2010 FDOT/FTBA CONSTRUCTION CONFERENCE

# Structures Construction Updates

FLORIDA DEPARTMENT OF TRANSPORTATION  
STATE CONSTRUCTION OFFICE

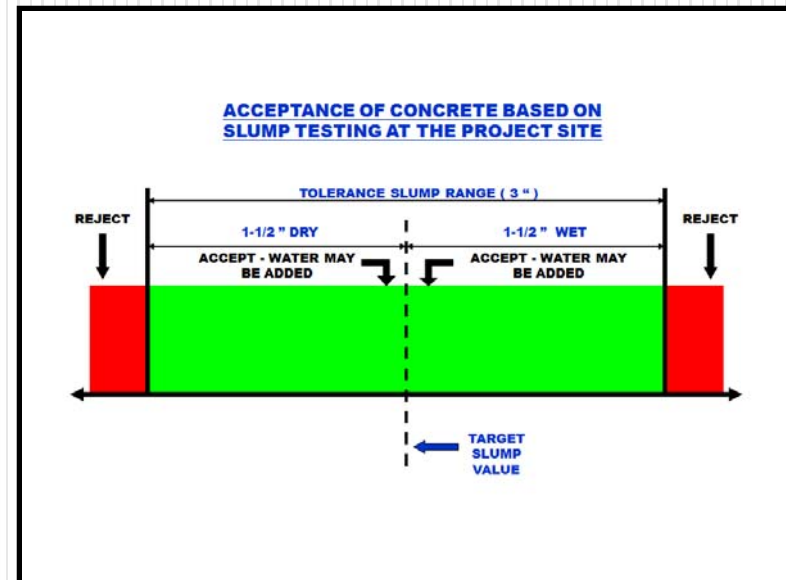
- The target range requirement will be eliminated in the next 346 Specification revision (Implementation July 2010)
- Water can be added as long as slump is inside the tolerance range and the W/C is not exceeded
- If the slump is outside the tolerance range but the concrete is placed instead of being sent back to the plant then a price adjustment will be made of twice the invoice price of that load
- No price adjustment will be made if the Engineer authorizes concrete placement even if the slump is outside of tolerance

## Specification 400-15.2.5.1: General – Class 4 Deck Finish

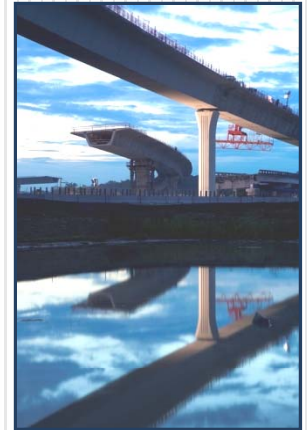
- Long bridge now defined as greater than 100' and the approach slab is not included
- Short bridge is 100' or less not including approach slab
- For bridge deck widenings, see the plans for the finish and smoothness requirements which are project specific

**FIB  
72" Depth**

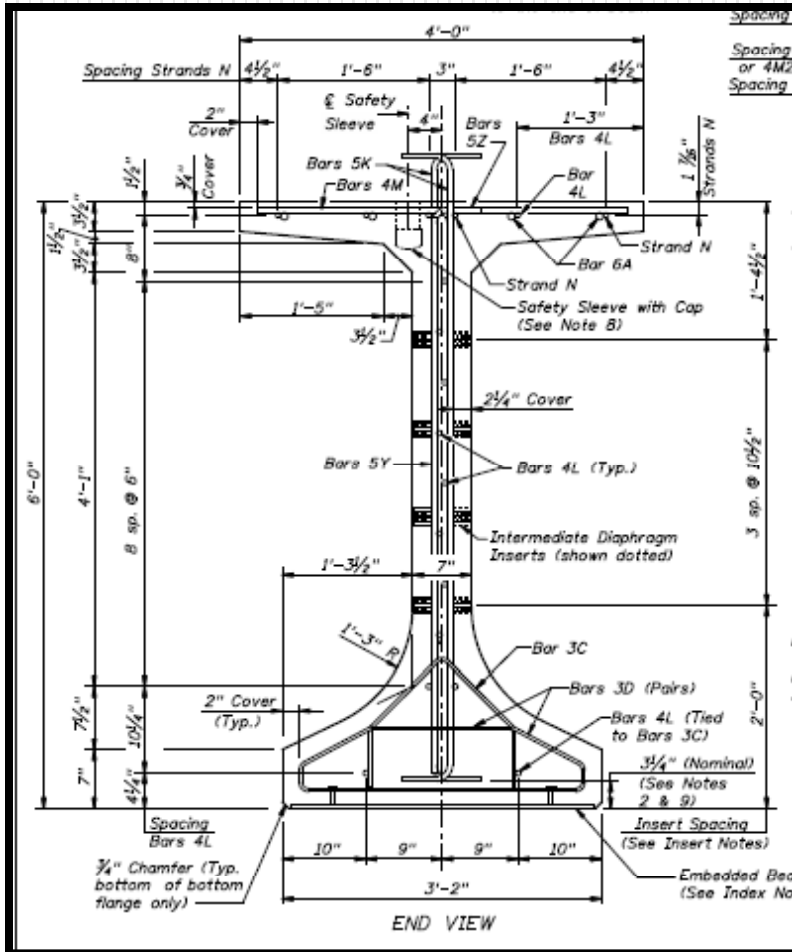
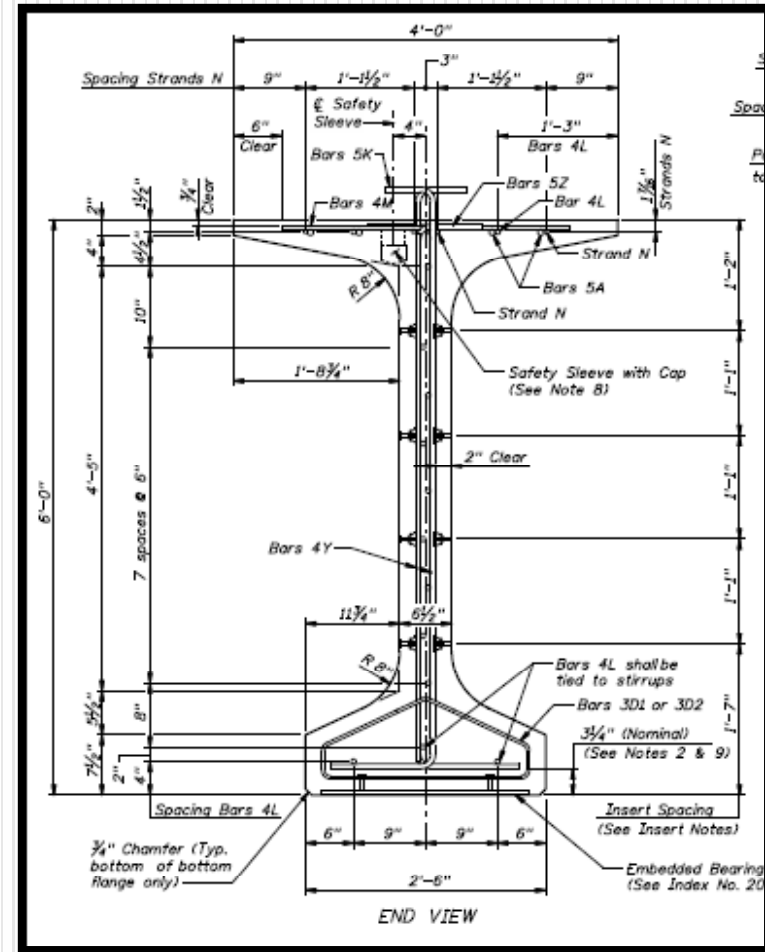
- FIB replaces most AASHTO and Bulb-T shapes
- Advantages of the FIB:
  - Higher load carrying capacity than same length AASHTO or Bulb-T which can reduce the number of beam lines resulting in a lower cost superstructure
  - Much wider and thicker bottom flange which reduces susceptibility to overturning during storage, handling and erection
  - Thicker flanges and web increases lateral stiffness which reduces susceptibility to buckling
